Comment Response Letter

Project Name: Pastry

Project File Number: DSRFY2023-0010

The following are updates from the previous Design Review meeting on February 5th, 2024.

ENLARGED
ELEVATIONS

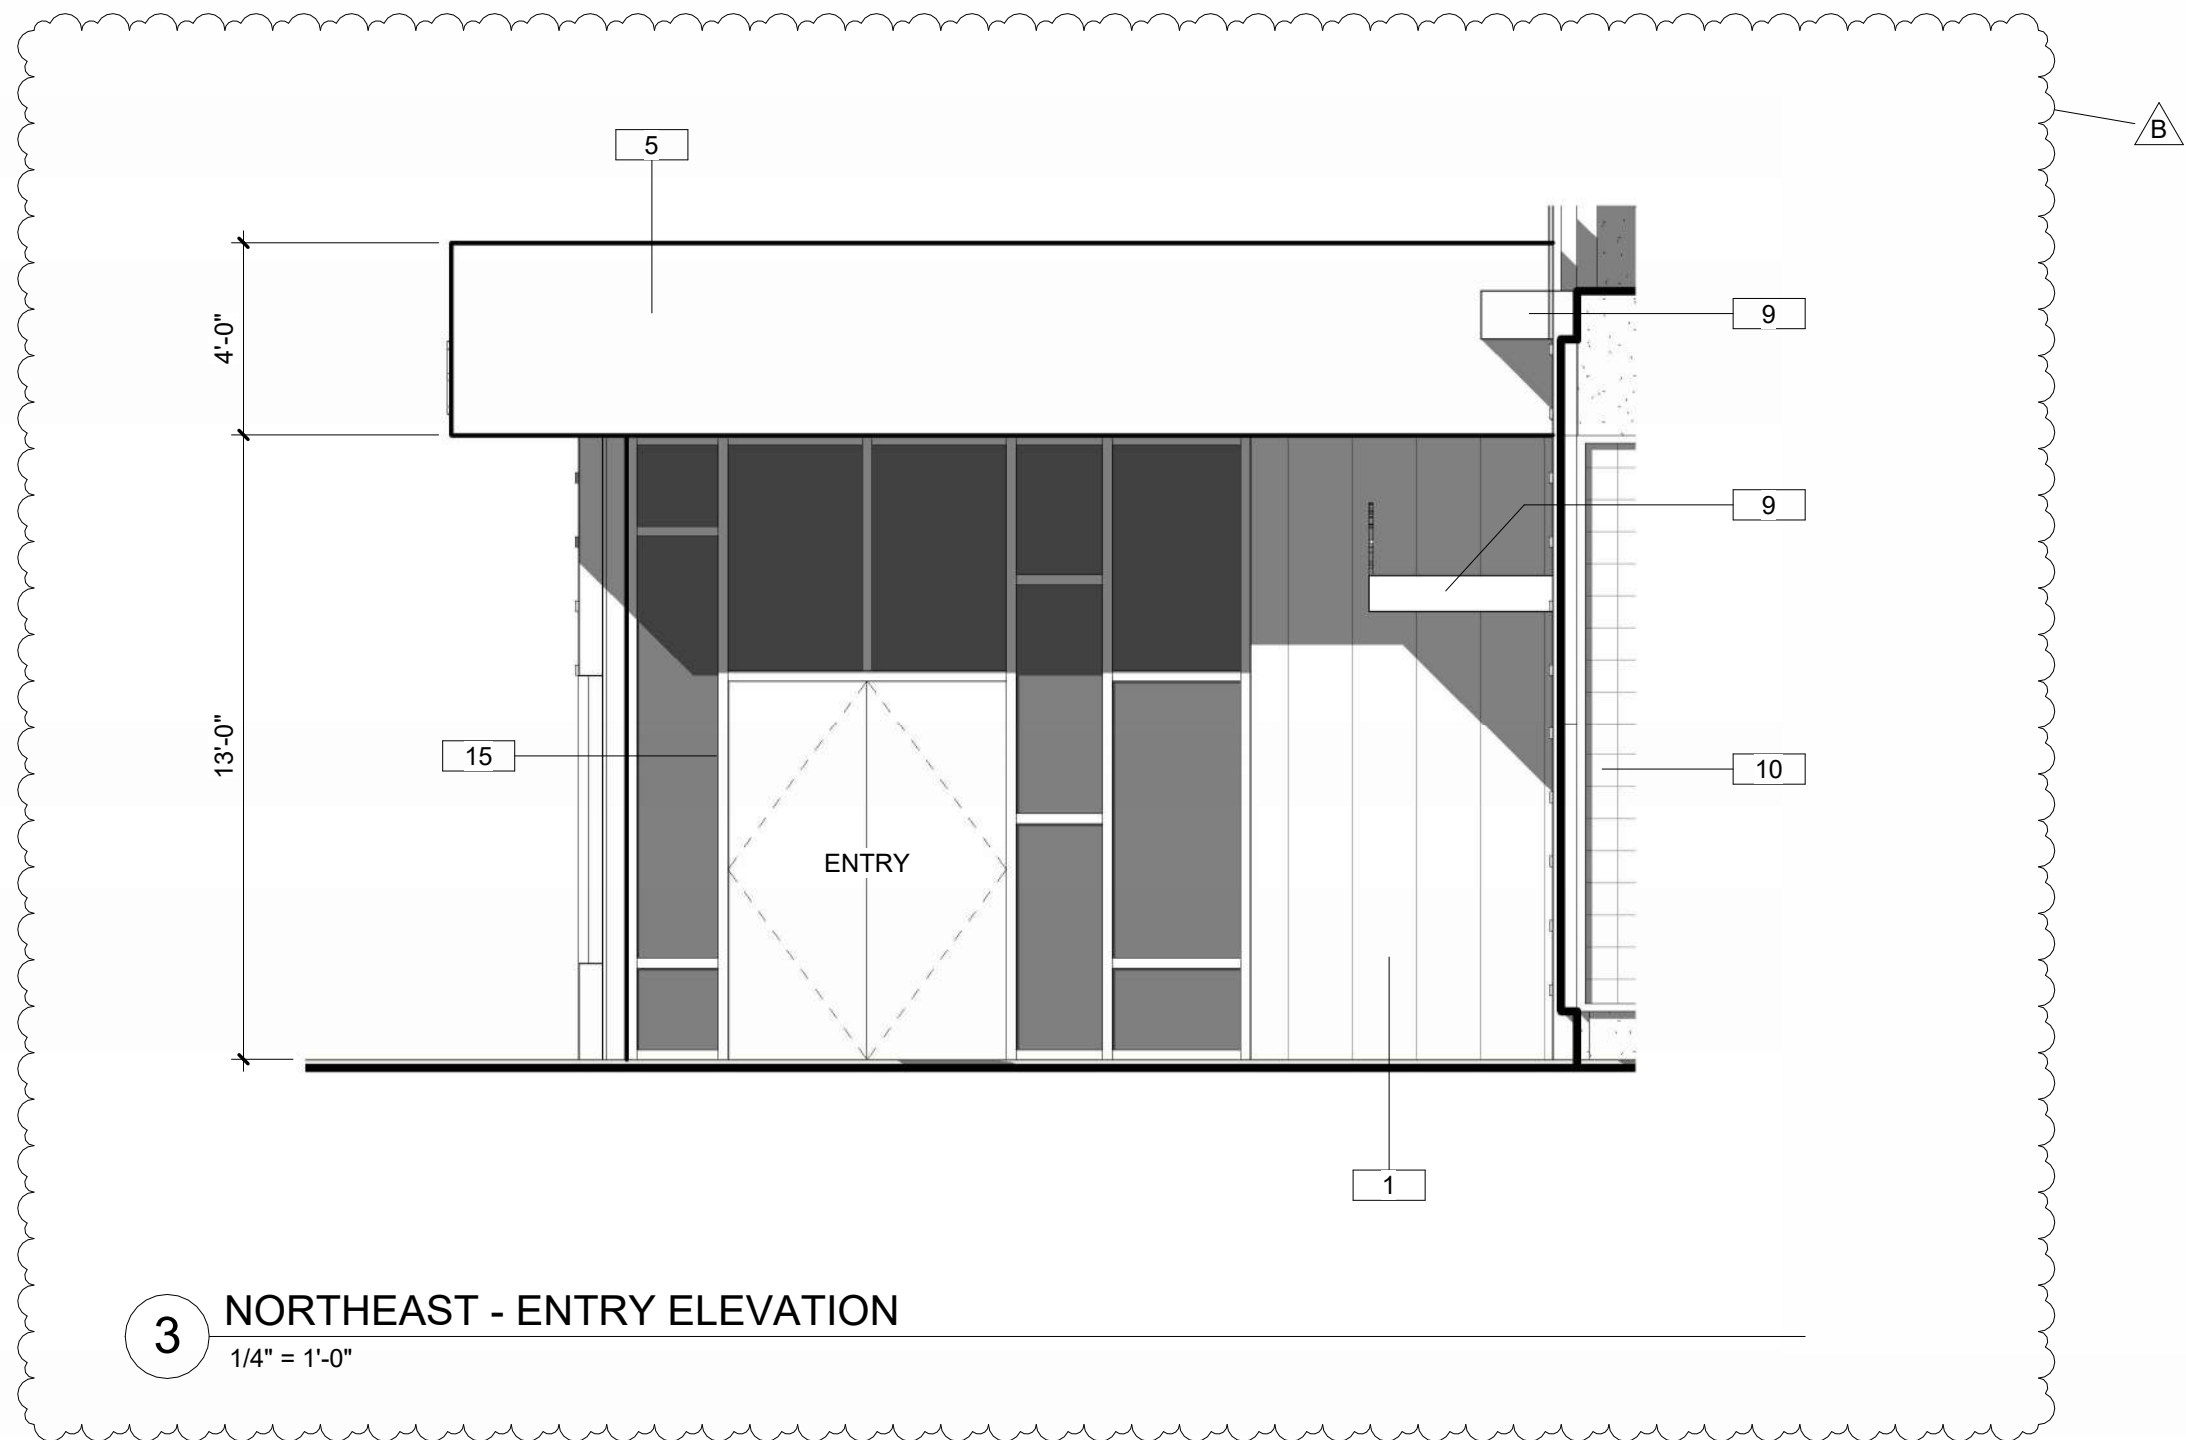
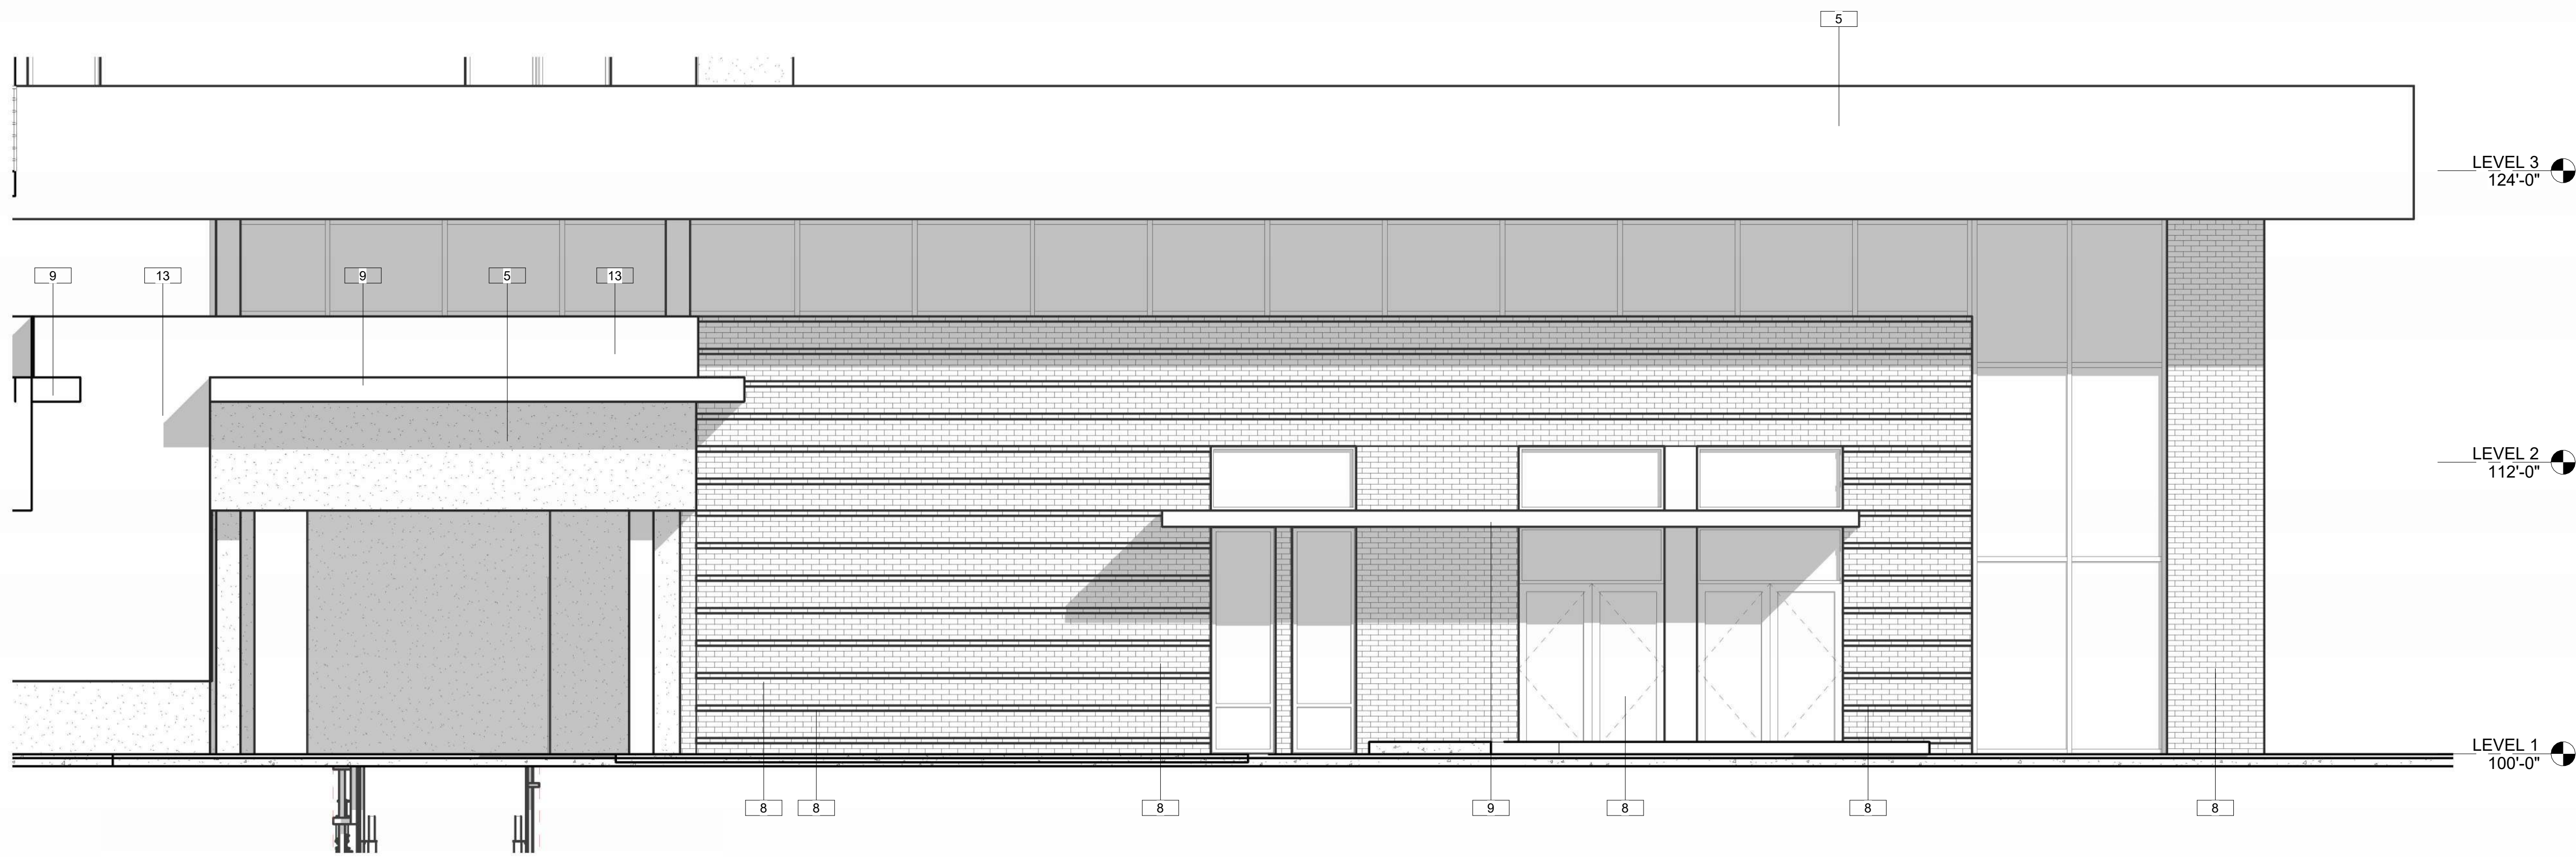
1. **Glenwood Entry.** The building was redesigned to include a new leasing office that directly fronts Glenwood Street. The leasing office provides direct access to the sidewalks along Glenwood Street. This main entrance was designed to be the obvious entry from Glenwood Street and to be a direct focal point of the building from Glenwood Street. Signage was added to delineate the leasing office entrance and the parking garage entrance. The new leasing office was designed to appear commercial in appearance and uses several elements to break up any longer expanses. The new design also incorporates new landscaping and a plaza just south of the new leasing office entrance. There is no drive aisle in front of that portion of the building, so as to provide pedestrian access directly to Glenwood Street without crossing any drive aisles from the building to the sidewalk.

MECHANICAL
SCREENING
EXHIBIT
A311

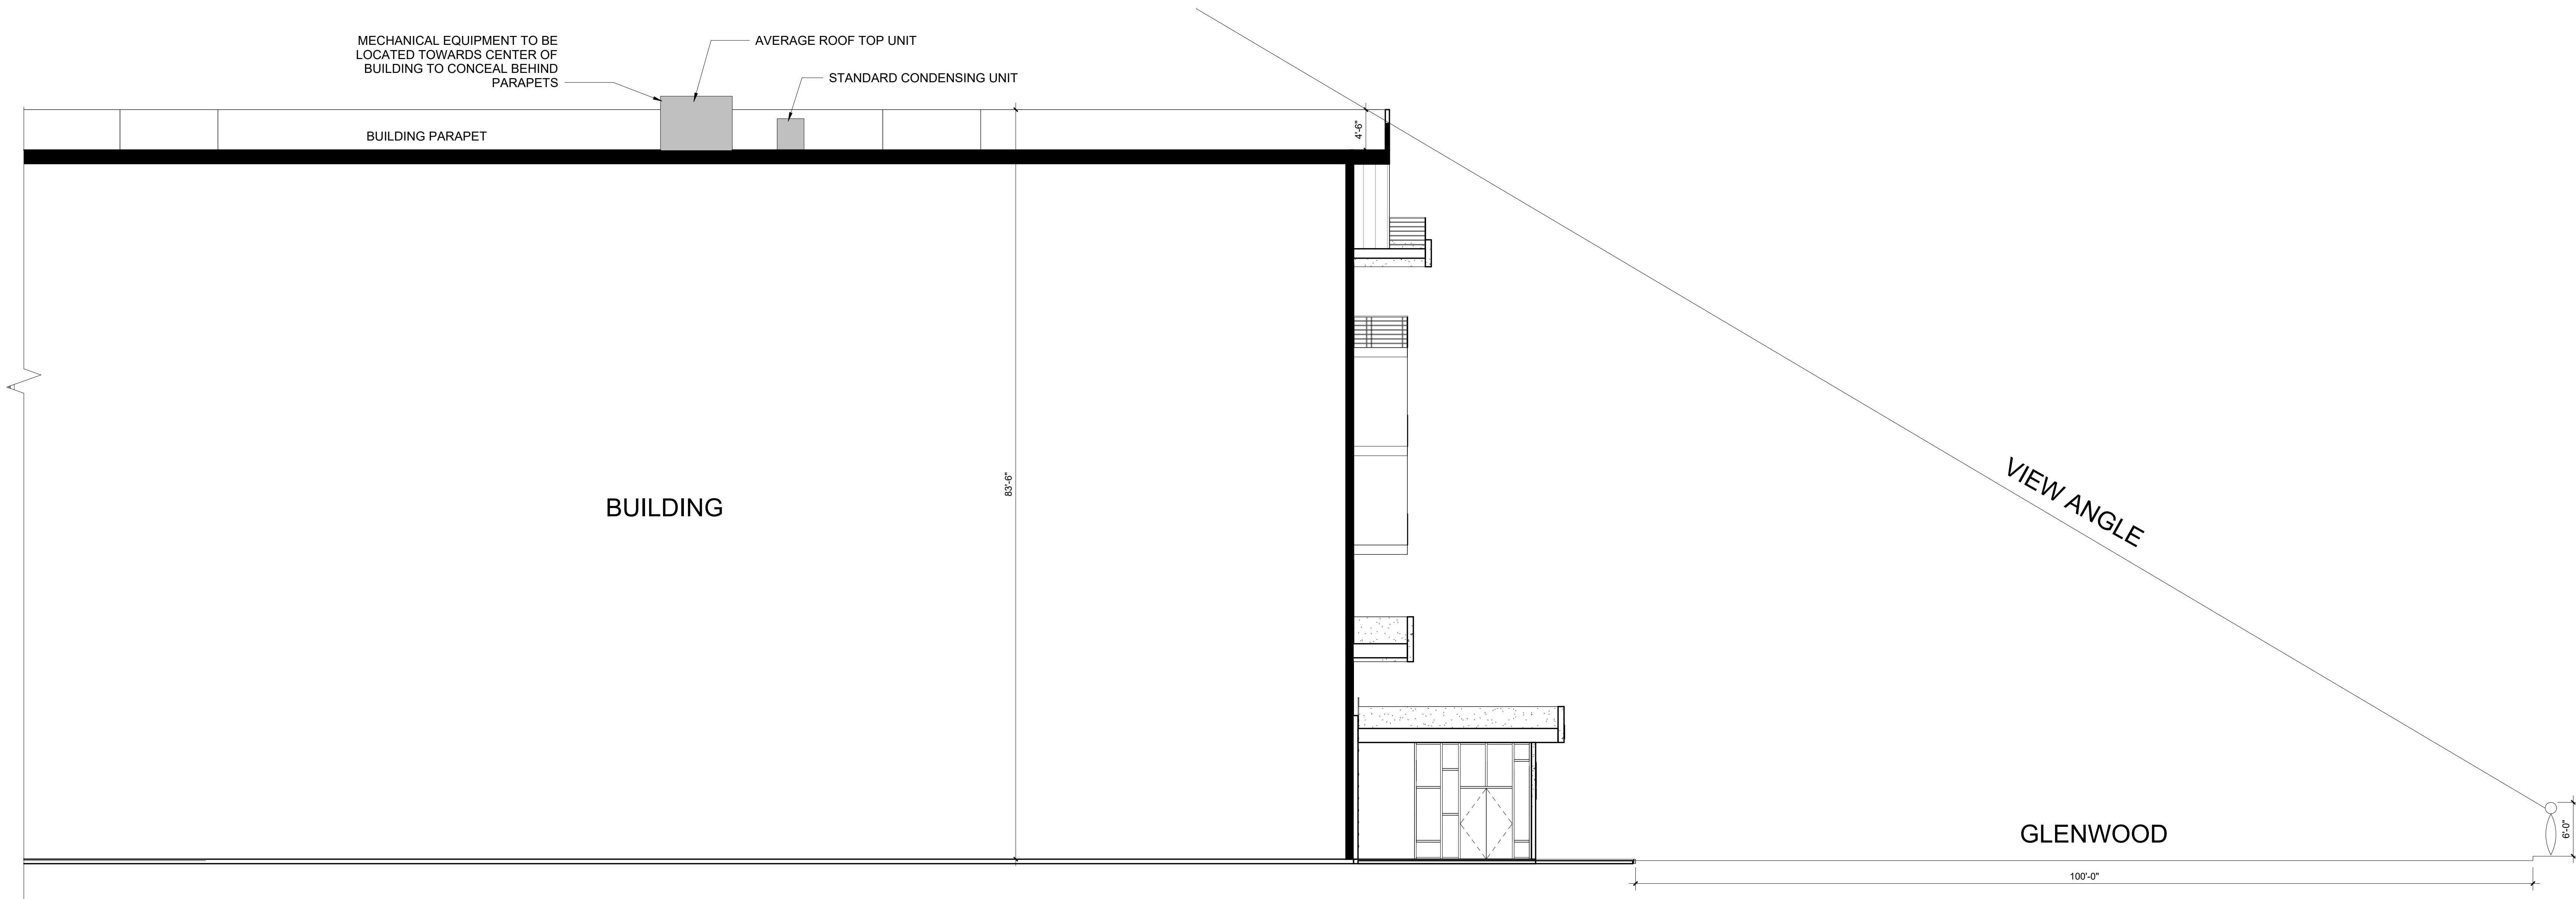
3. **Parking Garage.** A concrete wall is provided at both levels of parking to 4'-0" A.F.F. This concrete barrier serves to keep headlights from exiting the parking garage and will also support the proposed screening elements.

NOTES & DETAILS

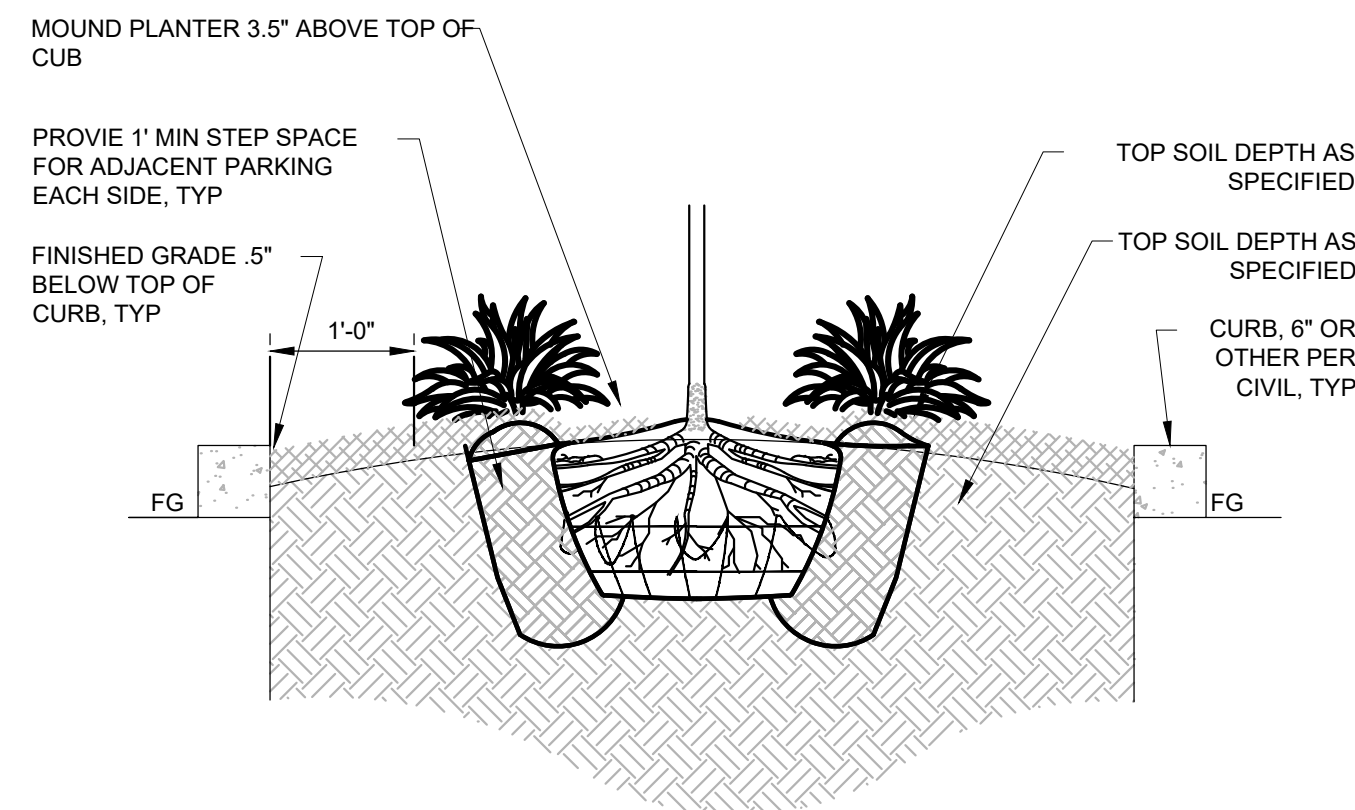
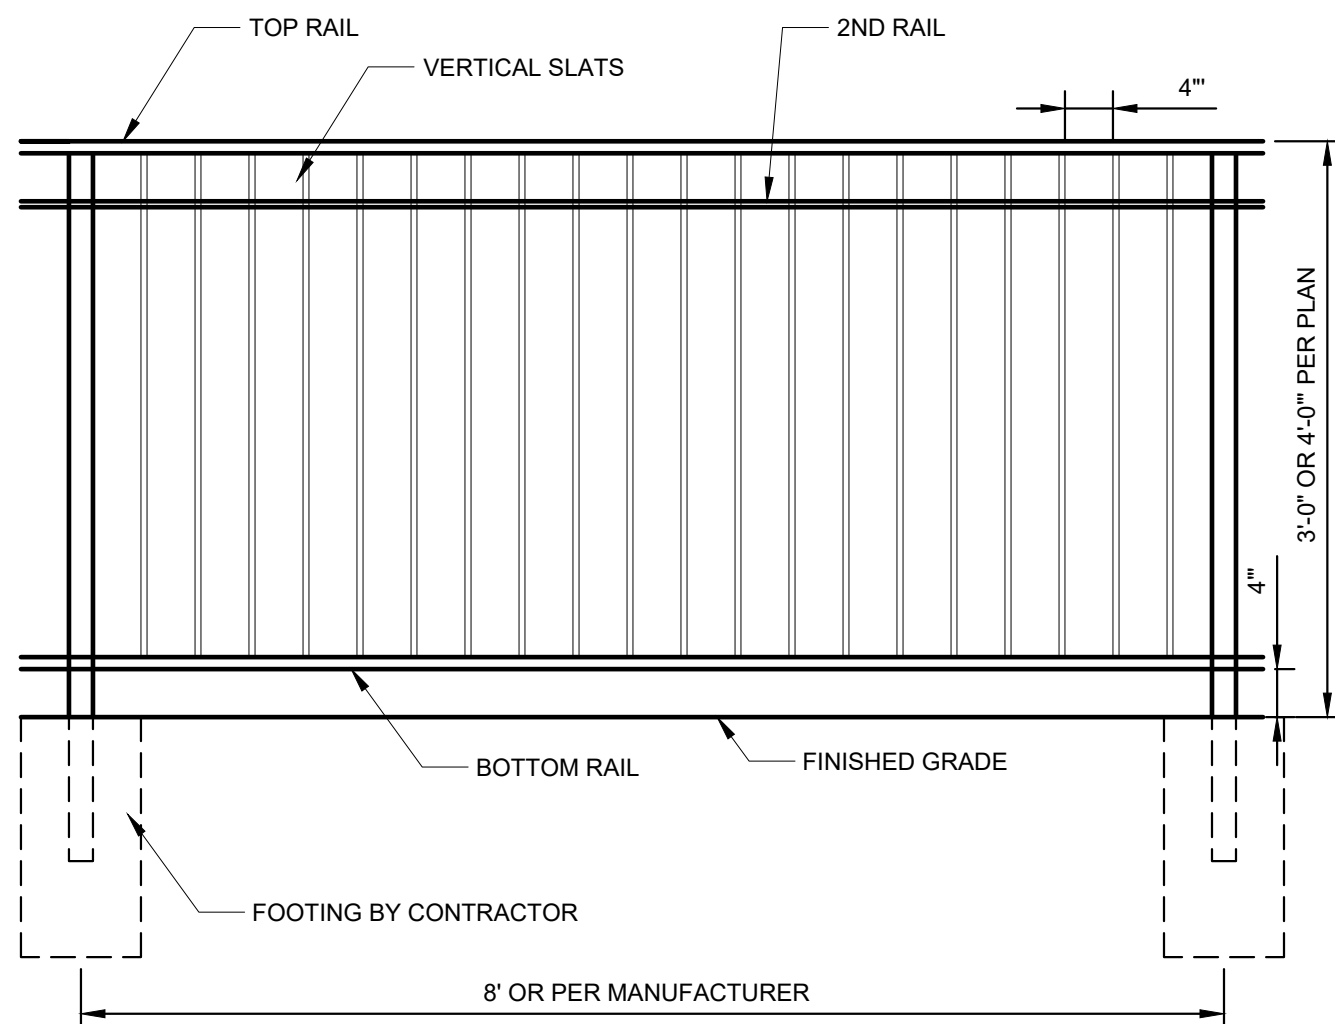
5. **Fencing.** The fencing plan was updated to provide location and types of fencing throughout the site.
6. **Pedestrian Crossings.** Direct access from the building to Glenwood Street is not provided so that pedestrians do not have to cross drive aisles to access sidewalks. The drive aisle that crossed directly in front of the building on Glenwood Street was removed. Additionally, pedestrian crossings on the west side of the building that cross drive aisles, as well as the trash enclosure area, are stamped concrete to clearly delineate those crossings.
